SIB 52 08 21

RECALL 21V-521: CIS MAT

2021-08-12

This Service Information Bulletin (Revision 1) replaces SI B52 08 21 **dated July 2021**.

For section: Installing the seat cover for the front seat REP-TAT-P-5216-02-G01_3

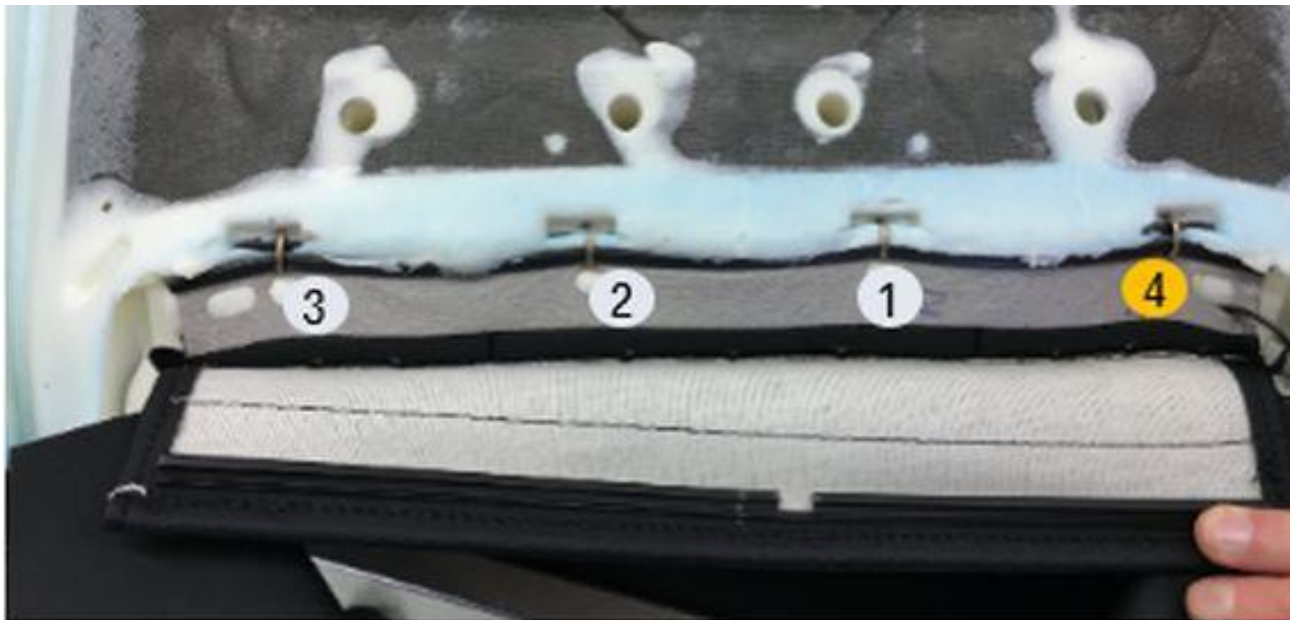
2. **Note: There is a changed procedure for clamping when installing the front seat cover- the new procedure below has not yet been incorporated into the repair instructions.**

New: The sequence in which the hog ring clamps are installed must be observed.

First clamp items 1-3, then clamp the area of the cable outlet 4 to prevent the seat heater line from being contacted and/or damaged by clamps.
